LEGAL ADVERTISEMENT PORTLAND PLANNING BOARD

To: Chair Dundon and Members of the Portland Planning Board

From: Caitlin Cameron, Urban Designer; Christian Roadman, Planner

Re: **June 12th 2018 Planning Board Workshop**
Level III Site Plan, Subdivision
2-Acre Redevelopment: office, commercial, industrial, retail, residential
86 Newbury Street (#000045-2018)
86 Newbury Street LLC, David Bateman, Applicant

1 | HANCOCK STREET ELEVATION
1/16" = 1'-0"

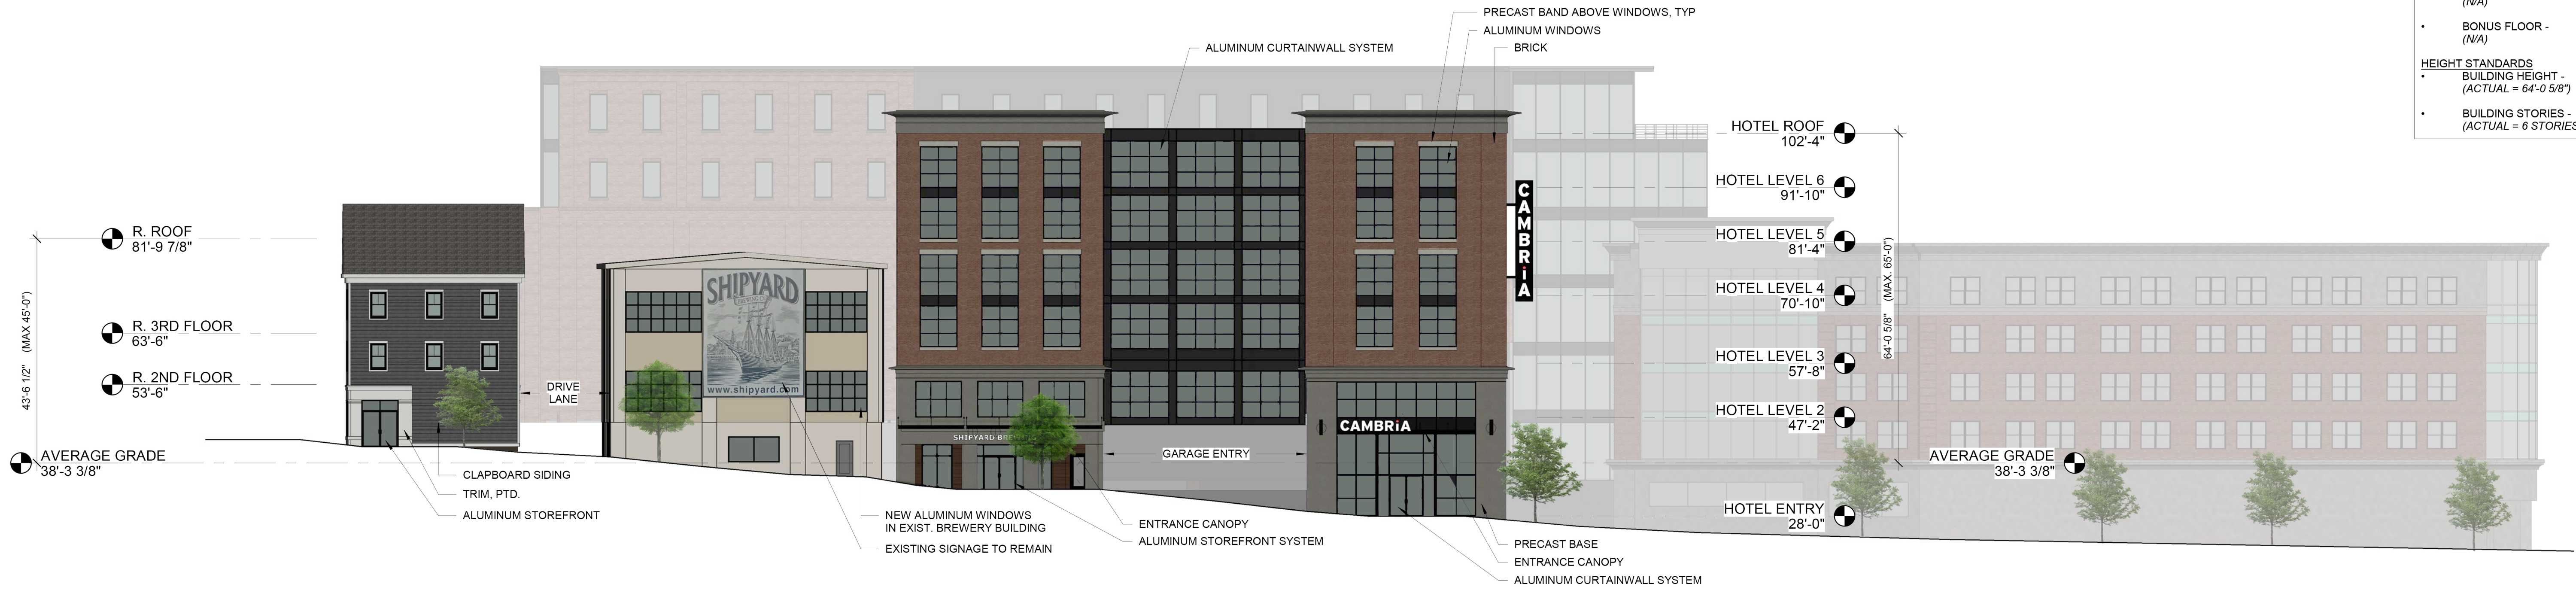
- further differentiate the spacing/ design of the three residential buildings (to read less like one development) – this could be through materials, entrance locations, plane changes
- make residential entrances more legible – either on the street or with canopies extended to street
- introduce a stronger edge to the proposed pocket park that reflects the scale of the Abyssinian building
- differentiate planes of the gabled and flat-roofed sections of the corner residential building
- reduce the “weight” of the ground floor retail – too opaque, heavy, office-front character, out of proportion with the overall building scale

fit into the established context. The hotel and existing Shipyard building continue the more active frontage that is being established on Hancock Street. Generally, staff feel to be contextual, new design in this neighborhood should be simple and consistent and use massing and articulation to provide human scale. The three residential buildings on Newbury Street are contextually sensitive in scale and provides an active ground floor with commercial use, however, staff and HP Board review feel some further revision is needed to the proportion of the retail façade composition, that more plane changes and articulation is needed, and especially that entrances

should be more direct and legible from the street. Staff are especially interested in mitigating scale and impact of the large office building on the surrounding residential blocks. The design successfully creates interesting forms and massing, and maintains the street walls. The building is setback from the street edge on Newbury Street to provide buffer to the small-scale residential across the street. Staff continue to **consider material placement and especially the use of curtain wall in this context.** The main entry to the office is on Mountfort Street and is occurs at a massing indentation/plaza in the building but **could use additional emphasis.** Visual interest is brought through massing variation, façade plane changes of the bay windows, and varied roof lines. There is a regular pattern of vertical proportioned windows, consistent with the traditional patterns. Staff would like to study the roofline of the hotel and office building in relationship to Fore Street and the overall skyline to better evaluate that relationship to the context. The project also adds some publicly accessible open space on Newbury Street. The space directly across from the Abyssinian is an amenity for the neighborhood residents and visitors as well as providing a point from which to appreciate the Abyssinian Meetinghouse – **the Historic Preservation Board and staff feel that the western edge of that space should be better defined either by shifting residential building 3 over and removing the driveway, or at the very least with a landscape wall.**

1
E0.00

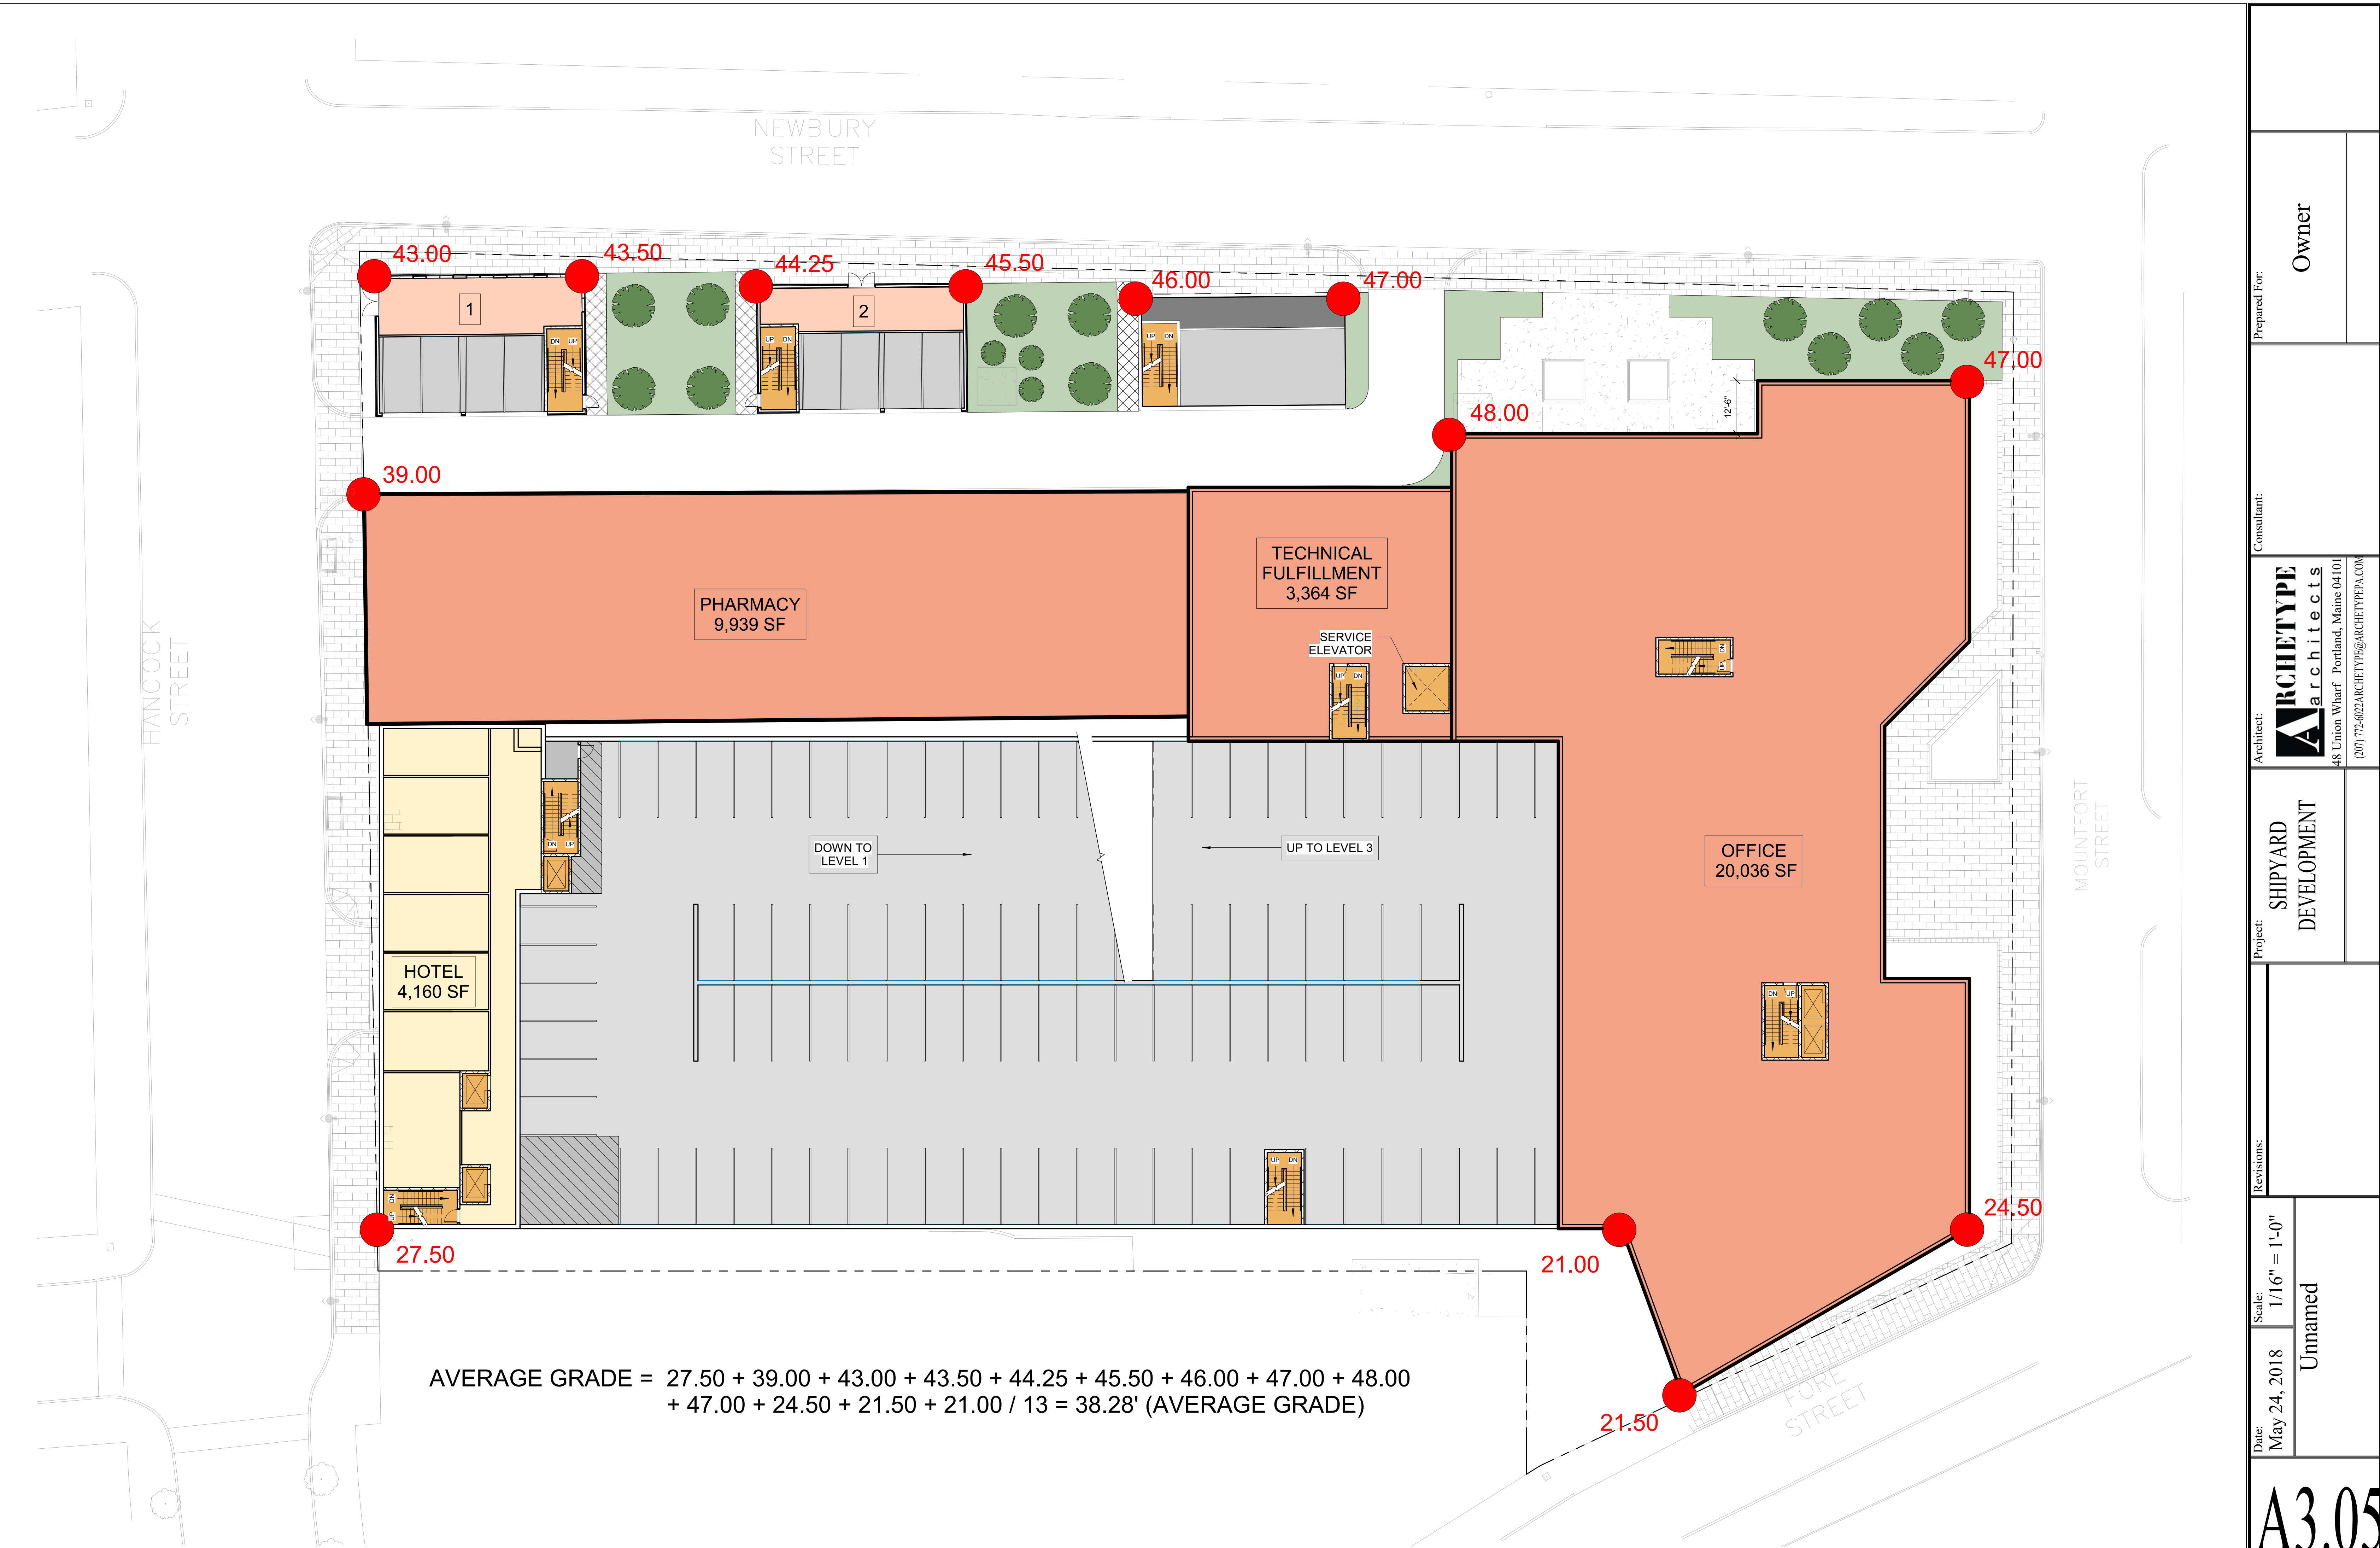
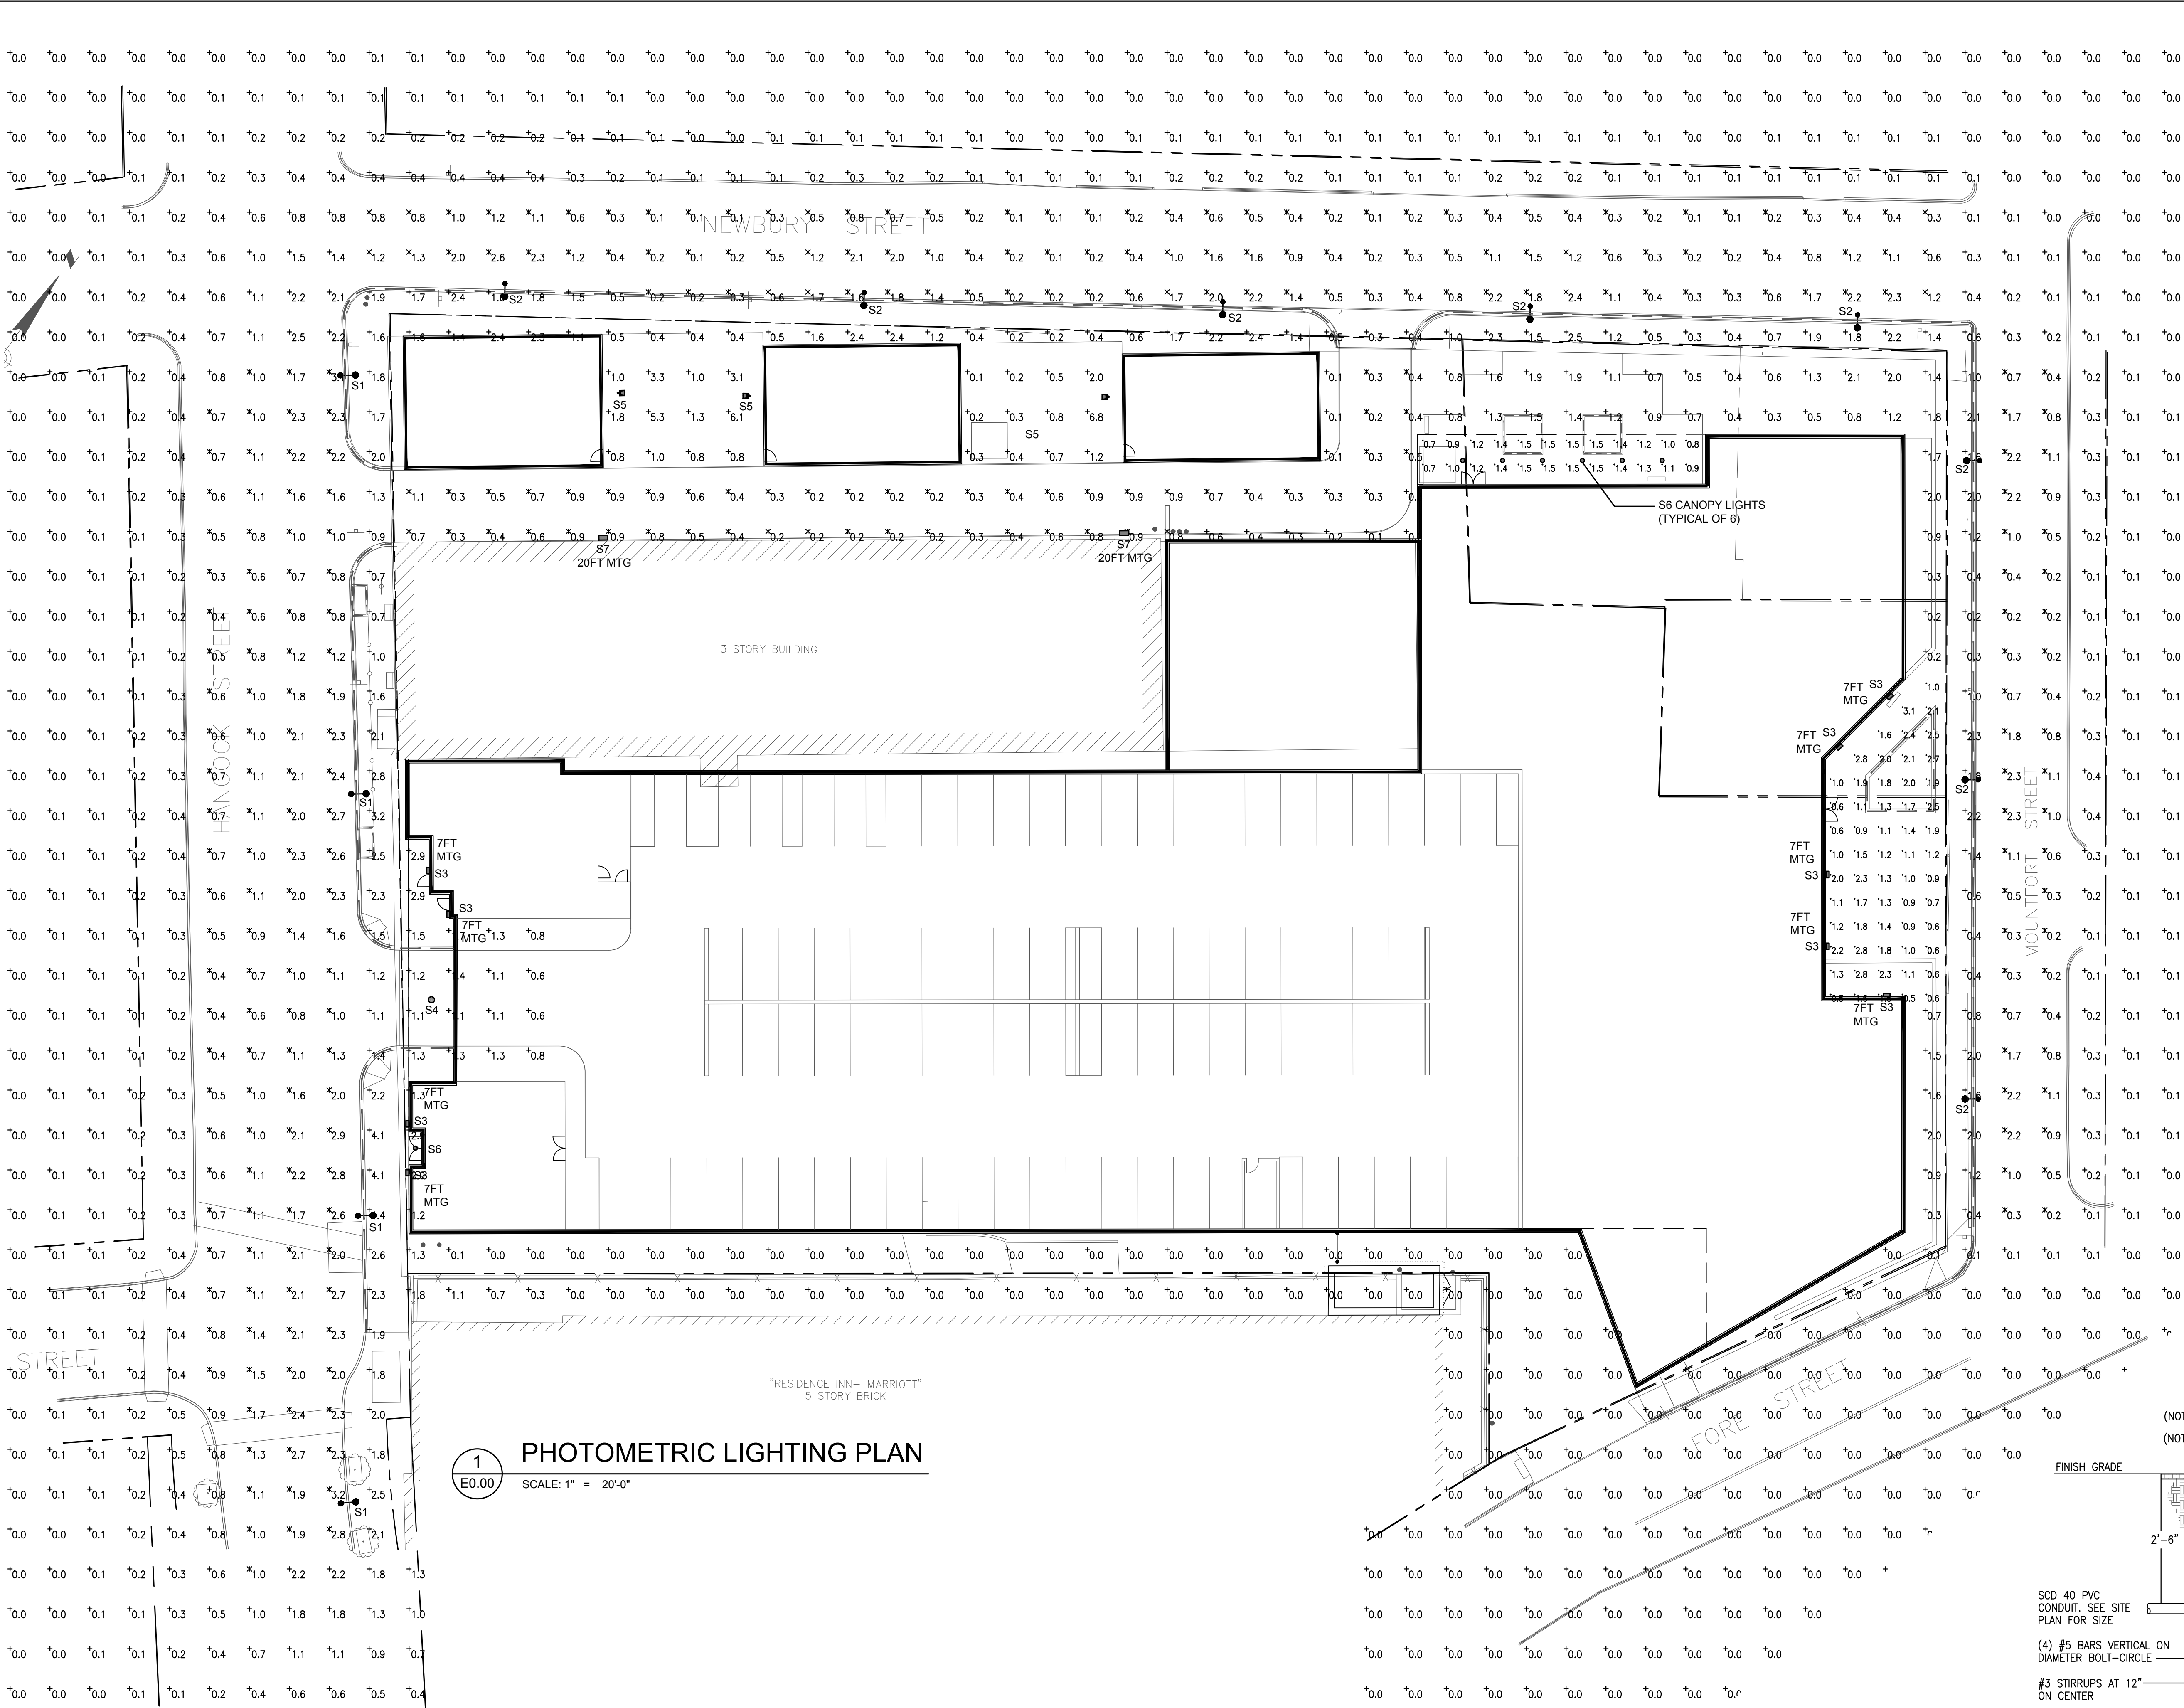
Exterior Lighting including Street Lighting – Staff evaluated the photometric plan – the minimum and maximum light levels are met in most cases. Lighting for the alley between Shipyard and the residential buildings is low. Most of the building entrances for this project are recessed away from the street – for this reason, building and site lighting levels is very important for safety reasons. The Building lighting cut sheets do not all meet the requirement for full cutoff lights – reconsider the sconce selection. Street lights are required along all frontages in the ROW, including Fore Street. The lights need to meet the Technical Standards for street lighting and match the lights installed elsewhere in the India Street neighborhood (Eastern Waterfront medium) – in this case, lights should all be medium scale, black, LED, and 3000 K color temperature.
